Affected Military Equipment:

CONSHELF XIV HOSES and OCTO HOSES

Part Numbers Affected: *Standard Hose Assembly, PN 090015*
Octopus Hose Assembly, Black, PN 090025, Octopus Hose Assembly, Yellow, PN 090039

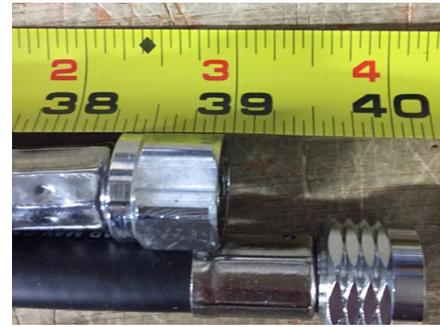
The only differences between the hoses are in the appearance of the swivel nut and the hose length. The UK product is approximately one inch longer. Refer to the photo above to note any visual differences.

To meet customer expectations in a timely manner, Aqua Lung will use two sources for finished hose fulfillment. The sources include both our Mexico facility and our Aqua Lung UK facility. Aqua Lung has evaluated the hoses produced at the UK facility and determined them to be of equal fit, form and function as those produced at the Mexico facility. Both hoses are used worldwide and comply with CE and all other standards set for breathing hoses. Both hoses are suitable for air or nitrox (up to 40%) use. Torque installation values and wrench sizes are the same for both hoses, and they are interchangeable with one another.

Please note part numbers will remain the same.
